## RESPONSE TO REQUEST FOR ADDITIONAL INFORMATION

### APR1400 Design Certification

**RAI No.:** 255-8285  
**SRP Section:** 03.08.05 – Foundations  
**Application Section:** 03.08.05  
**Date of RAI Issue:** 10/19/2015

### Question No. 03.08.05-9

**Figure 1. Dimension of Construction Sequence Foundation Media Model**

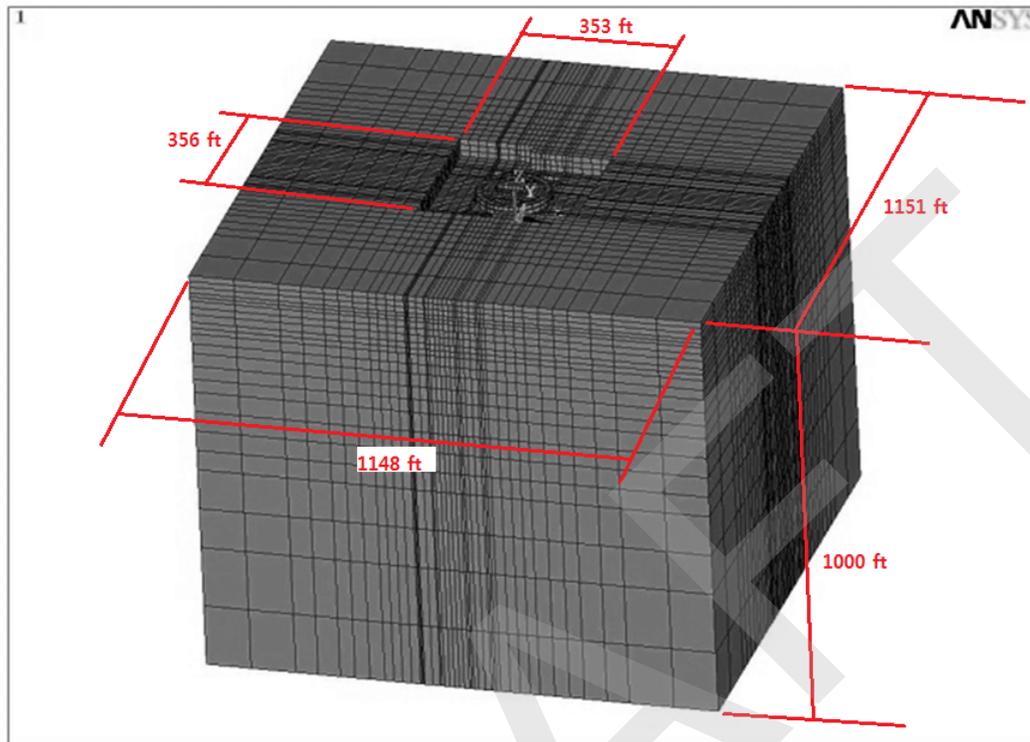
Therefore, the applicant is requested to describe the design and analysis procedures to explain how the elements described in SRP 3.8.5.II.4 E, J and K are incorporated in APR14000 design, and include this information in DCD Section 3.8.5.

The construction sequence analysis model consists of foundation media (soil layer, SOLID185 elements in the ANSYS program) and the NI common basemat. To capture the Boussinesq effect in soils, the foundation media model is used instead of the soil spring model. The ratio of the width of basemat is  $(1148 \text{ ft}) / (353 \text{ ft}) = 3.25$  and the ratio of the width of the foundation media is  $(1151 \text{ ft}) / (356 \text{ ft}) = 3.23$  which exceeds the ratio of 3.0. For the depth of foundation, the full depth of the generic soil profile was used to determine the ratio,  $(1000 \text{ ft}) / (356 \text{ ft}) = 2.81$ .

The foundation media model was developed using the same methodology as specified in technical report (APR1400-E-S-NR-14006-P, Rev. 1) and will be used for the basemat analysis and construction sequence analysis with actual site profiles.
